NSLPP MEETING HELD ON 01/06/2022
SECTION 4.55 APPLICATION –
SUPPLEMENTARY REPORT TO LPP 05 02/03/2022

ADDRESS/WARD: 182 Kurraba Road, Kurraba Point

APPLICATION No: DA 333/19/4

PROPOSAL: Supplementary Report – Modifications to a consent for alterations and additions to convert a duplex into a residential flat building with strata subdivision.

Figure 1 – Excerpt of Section A- A drawing No DA_300_00 (Daniel Younan & Assoc)

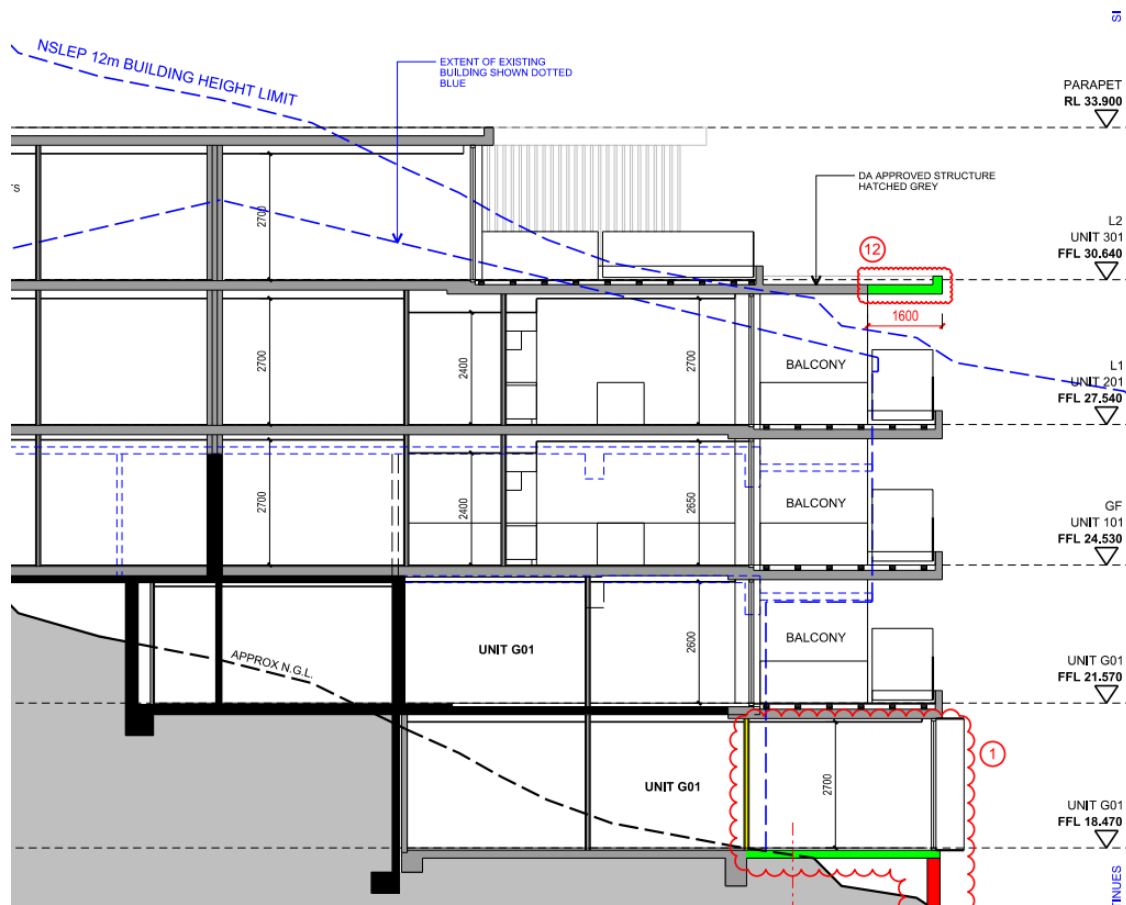
The modified proposal involves a minor projection of the pebble deck roof over the rear balcony of Unit 201, on Level 1, this projection will encroach slightly into the 12m height plane on the northern side of the development. The approved design already involves a breach of the 12m height of buildings standard on part of the north east corner of the roof. The modified proposal involves a minor increase in that breach caused by the roof projection.

The additional breach can be seen in Figure 1 below and its only purpose is to provide better weather protection for the unit below. The top of the roof or deck is non trafficable.

As no significant impacts will occur as a result of the roof projection, the minor variation would not be inconsistent with the objectives of the standard in terms of compatibility with the local area character, not significantly affecting bulk and scale, and improving amenity for the residents.

Figure 2 - 10m & 3.8m wall highlighted yellow on stamped plans for s.4.55 DA 333/19/2 issued 9.6/2021.

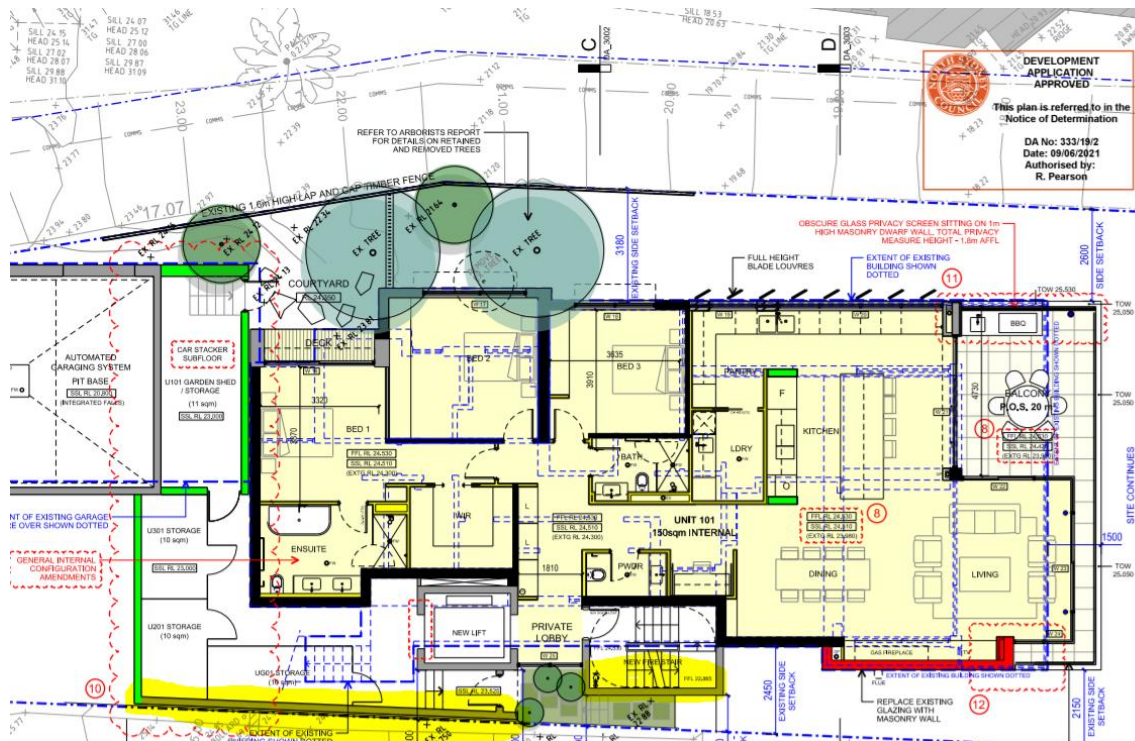
Comment: The 'new' 10m wall on the southern boundary and shorter 3.8m wall to the fire stairs were approved in the original DA 333/19 consent and s.4.55 modification. (See Fig 2 below).

Both of the walls highlighted in Figure 2 have been previously approved and not the subject of this current s4.55 modification.

DRAWING TITLE		SCALE	DATE	DRAWN
PROPOSED LOWER GROUND FLOOR PLAN (LOWER)		1:100 @ A3	JULY 19	DY
PROJECT NO.	DRAWING NO.	REVISION		
1912	DA_100_00	08

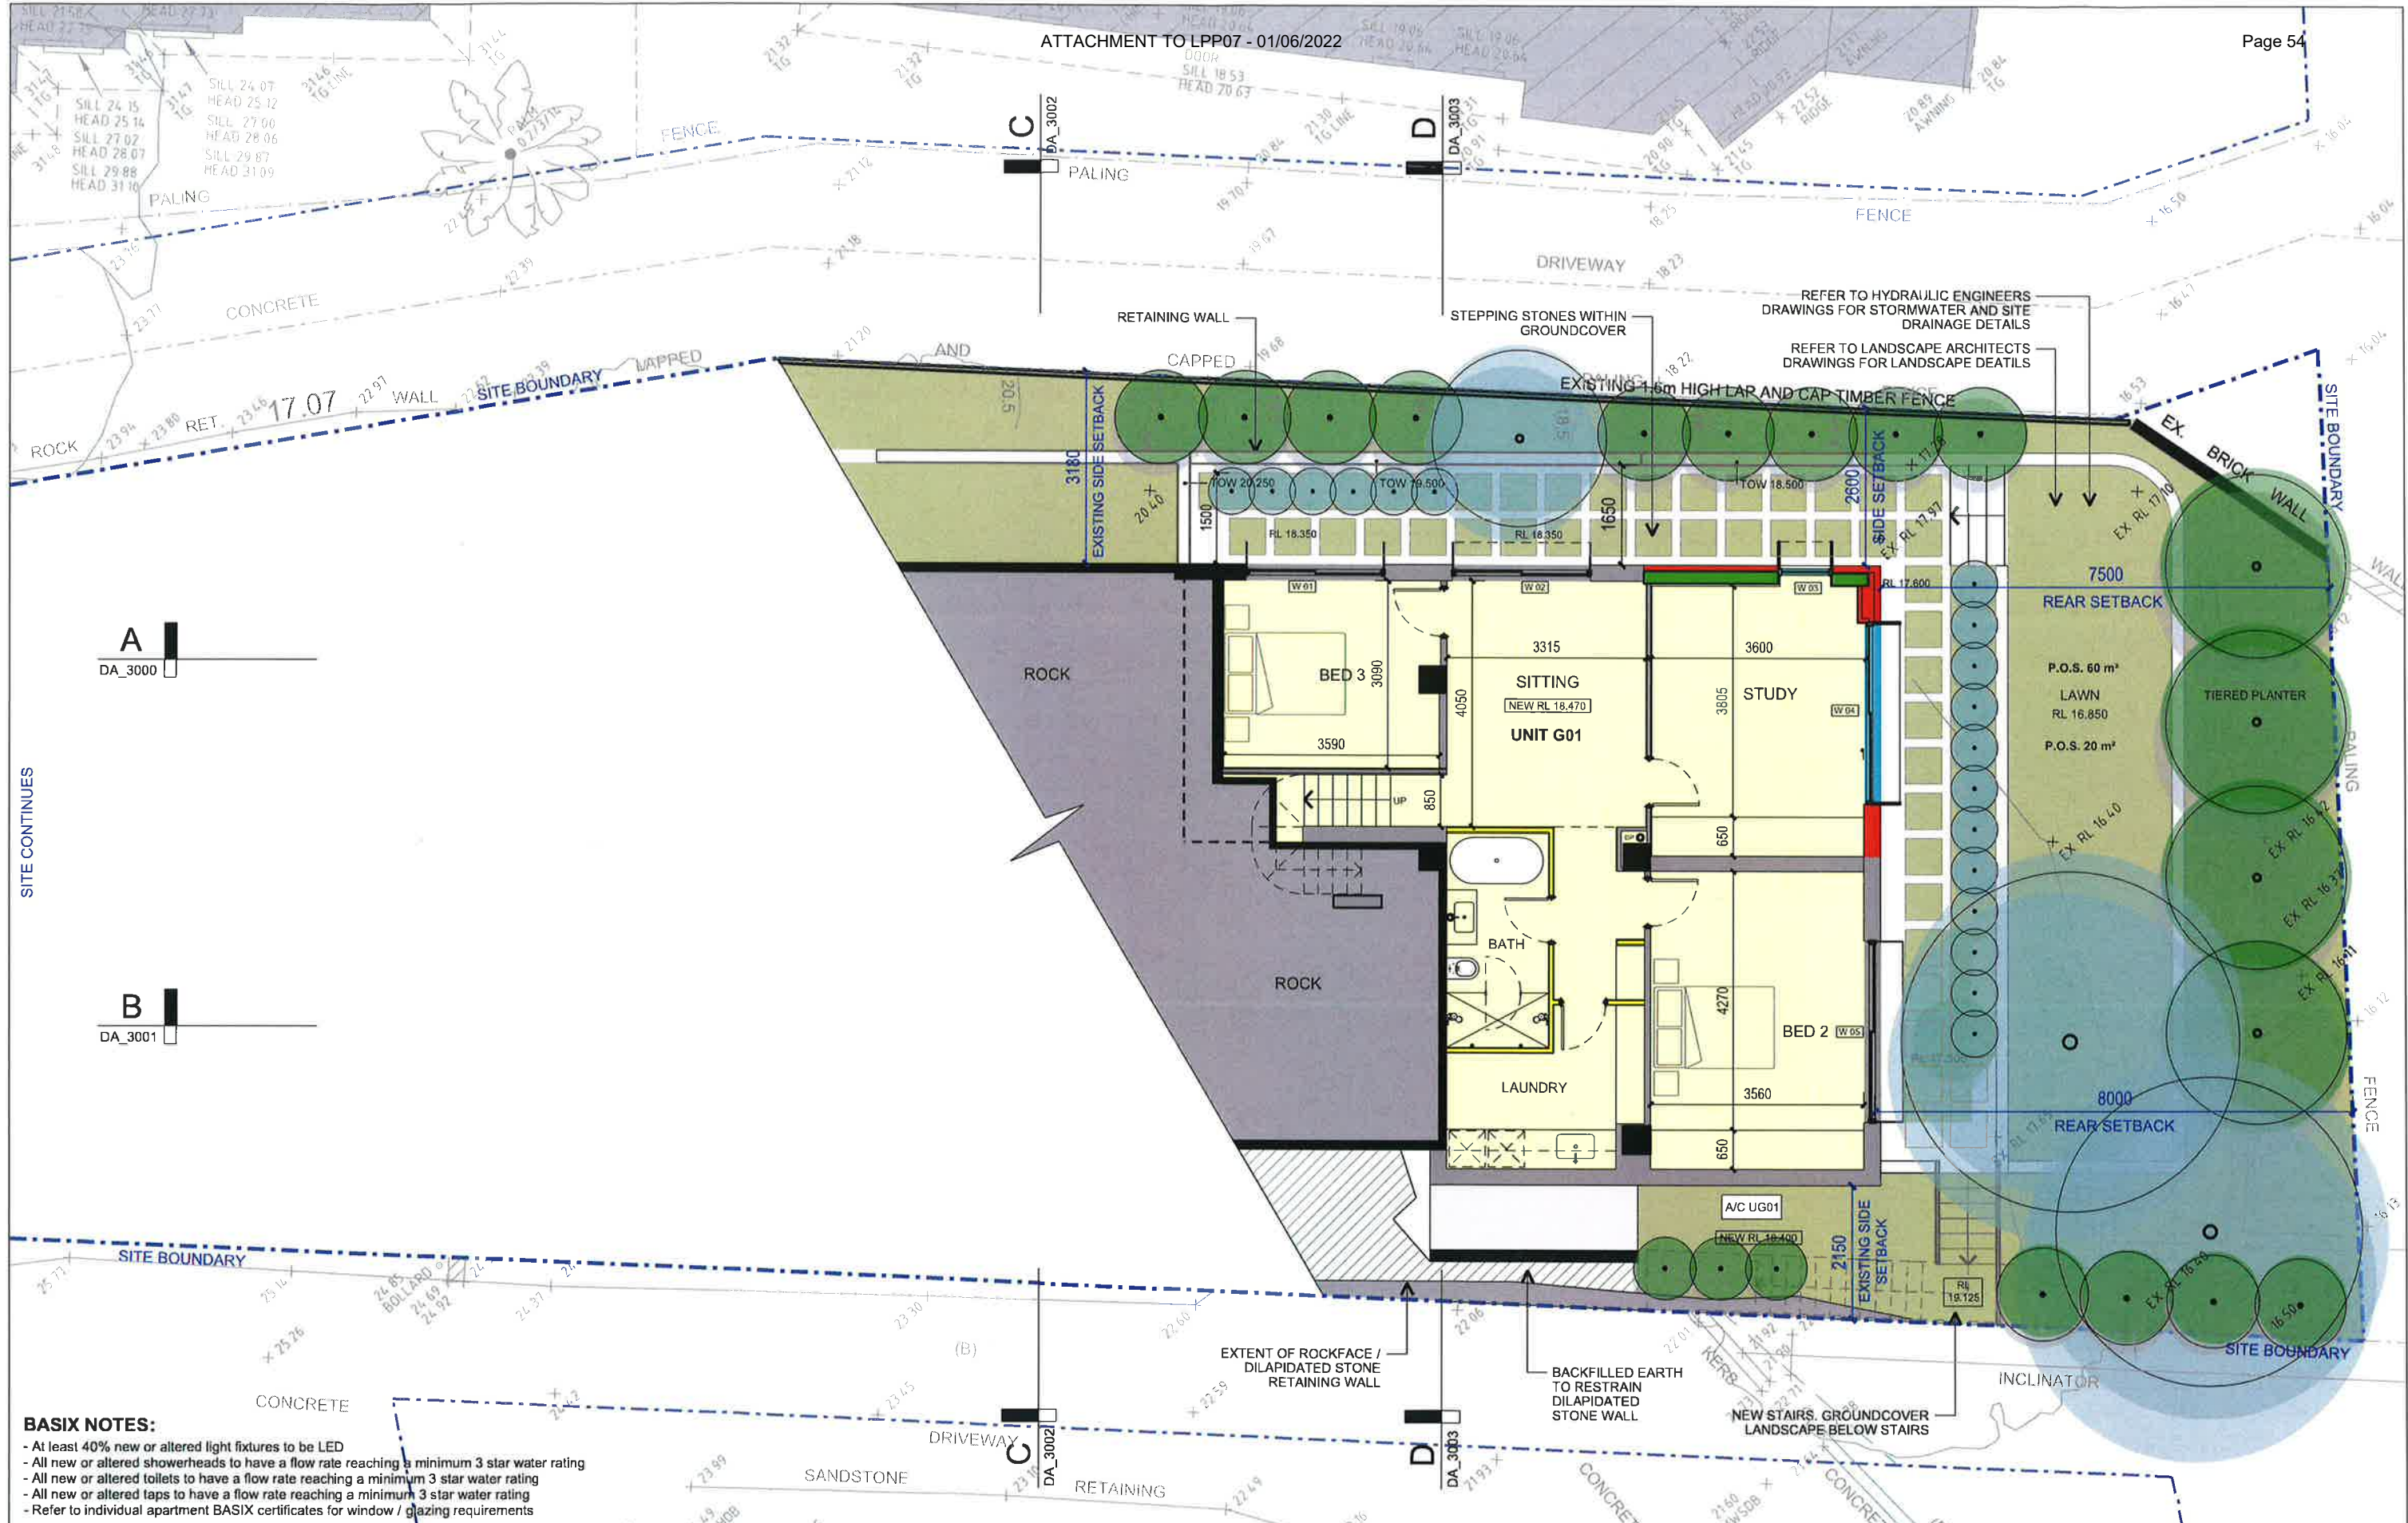
- *The laundry extension at the lower ground level is not approved and is to be deleted and is to be replaced with soft landscaping with a garden bed level of approximately RL18.470.*

- the maintenance of the currently approved garden and motorcycle parking space at the Lower Ground Floor (upper) RL 21.48 (drawing DA-1000-10 revision 8) ; and
- the unauthorised extension of the laundry at the Lower Ground Floor (Lower) plan being revised to a void space with appropriate retaining structure to the southern boundary RL 18.40(drawing DA-100-00 revision 8).

These plans effectively and practically address the Panel's decision as the works at the upper level revert to what has been approved in previous modifications and the works at the lower level remove the unauthorised and non-approved works.

PROJECT NO. 1912
DRAWING NO. DA_100_10
REVISION 08

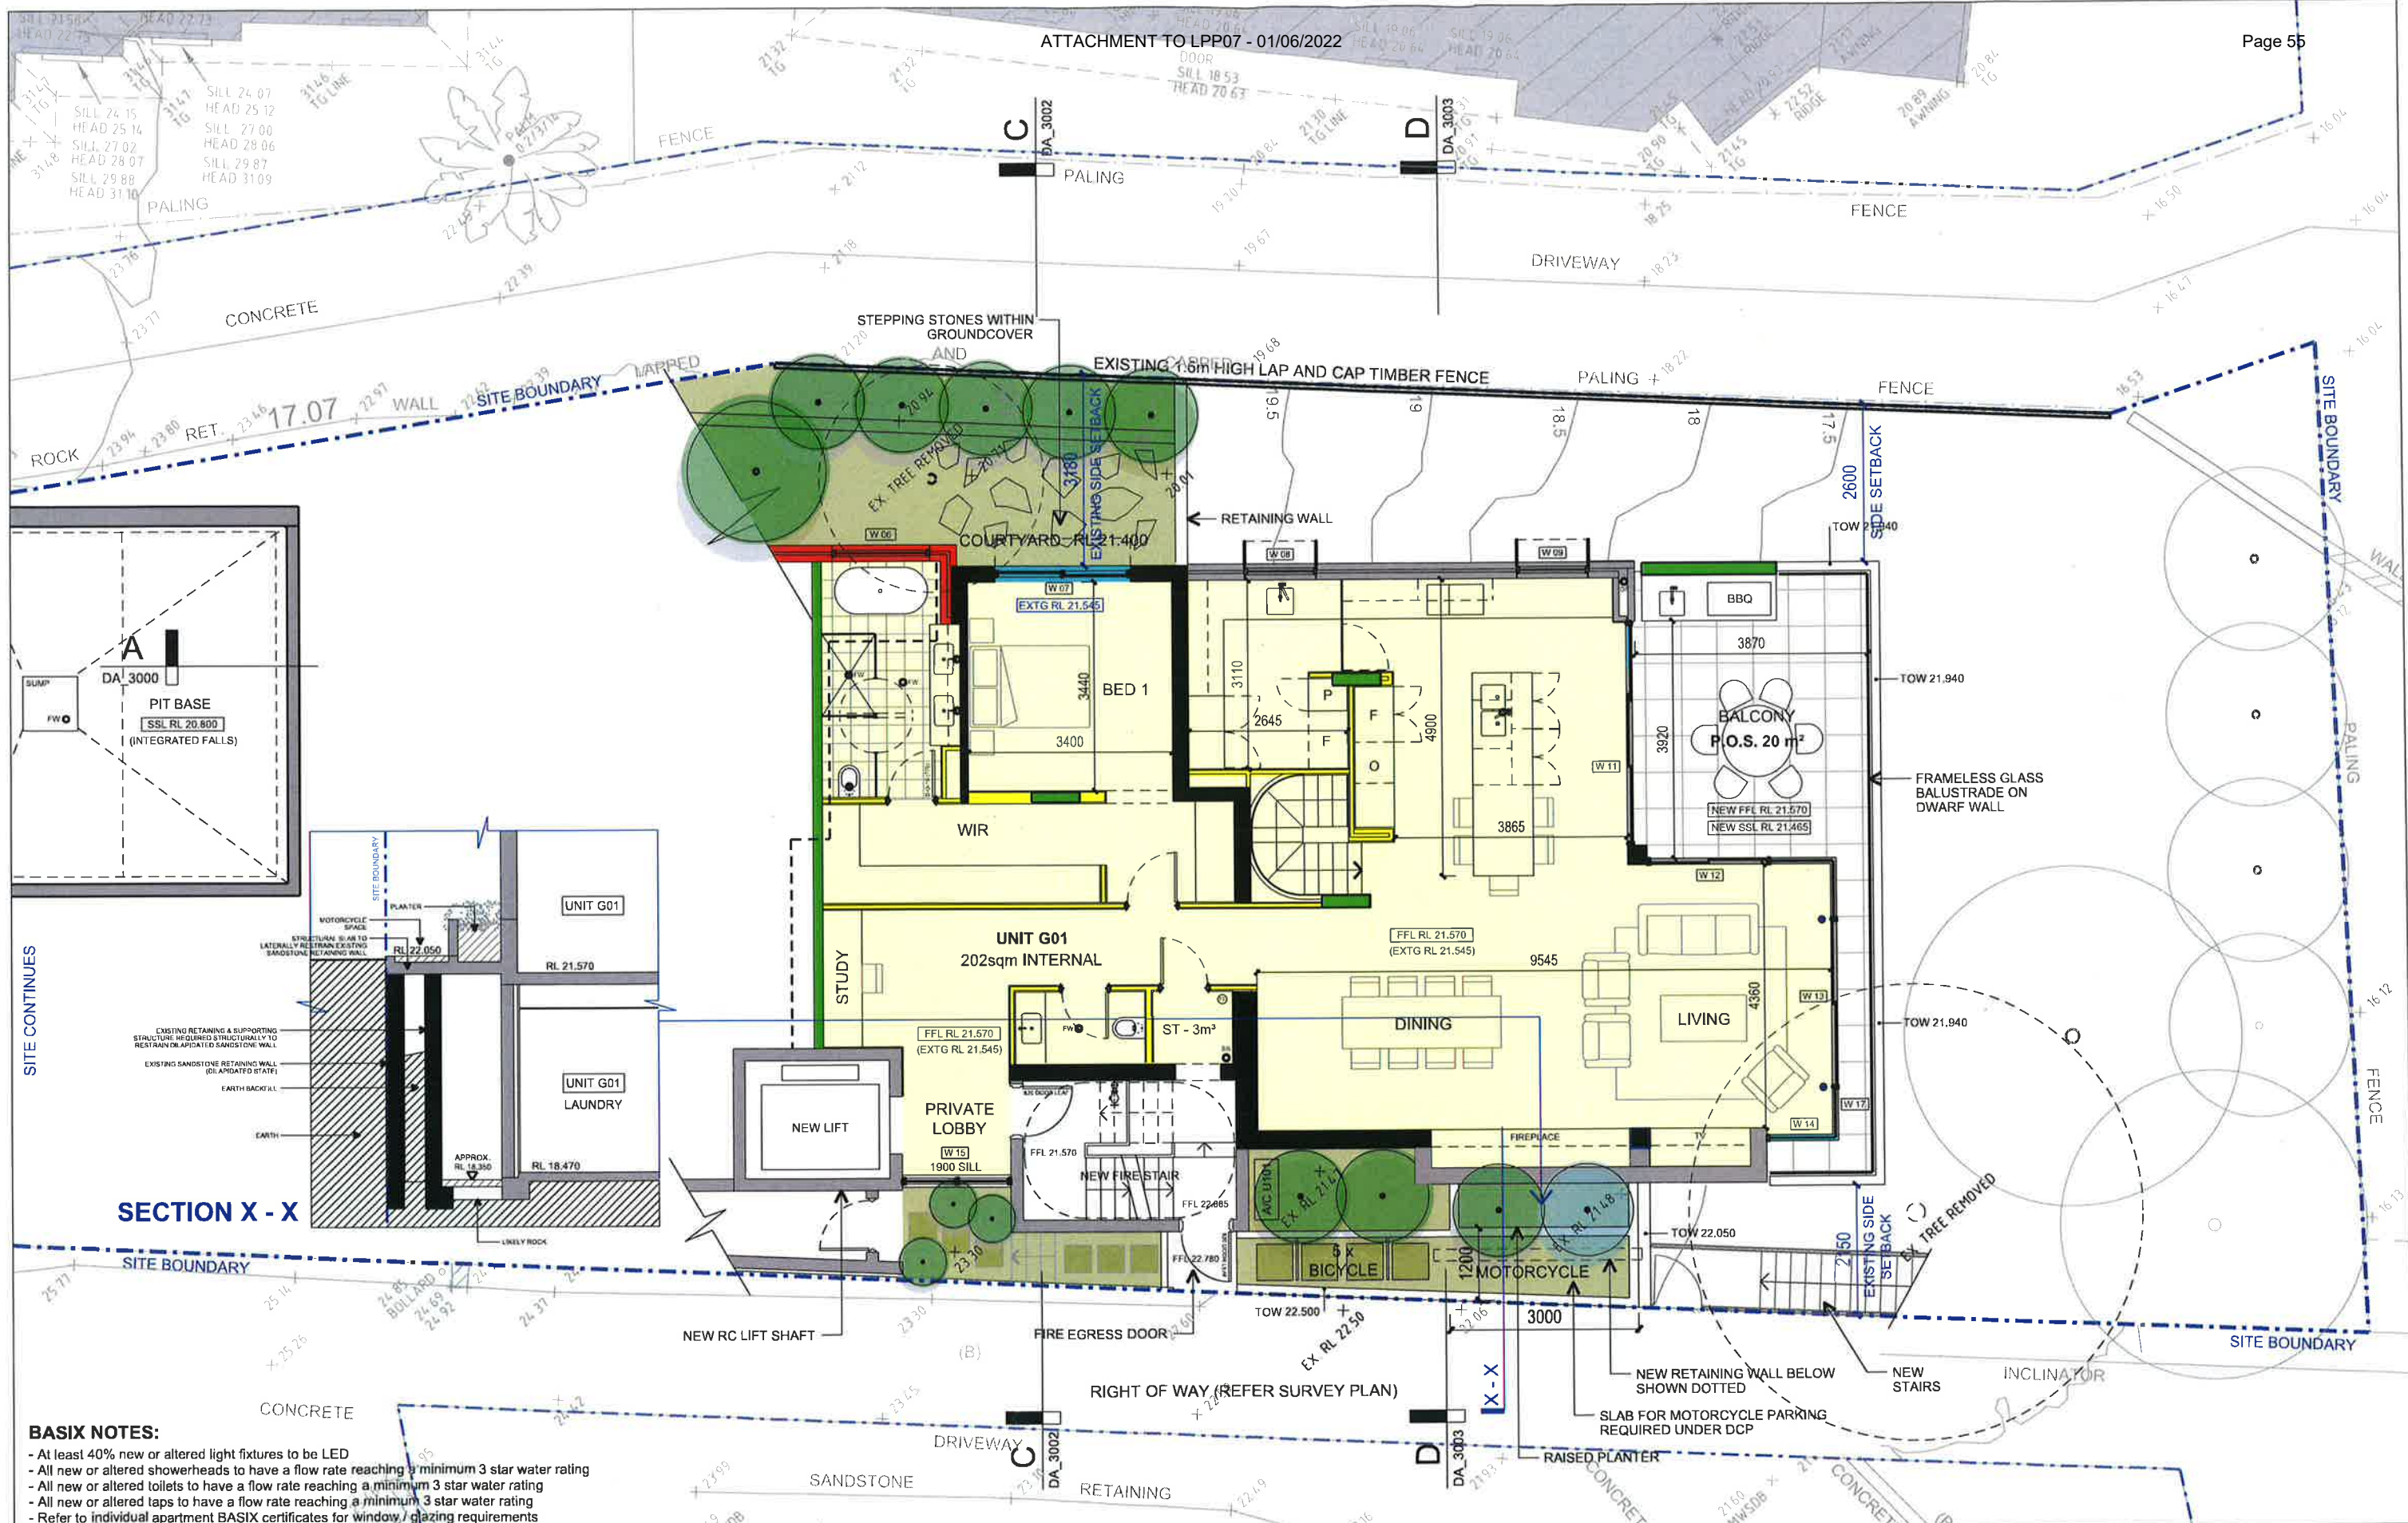
As originally submitted the amended plans addressed this request by providing garden bed at RL18.470 as shown on drawing Project number 1912 Drawing No_1000_00 Revision 07. However, this space is effectively without access to the sky as it is covered by already approved landscaping and a motorcycle parking spot located at RL 21.4 and proximate to the driveway on the adjoining property at 184 Kurraba Road.
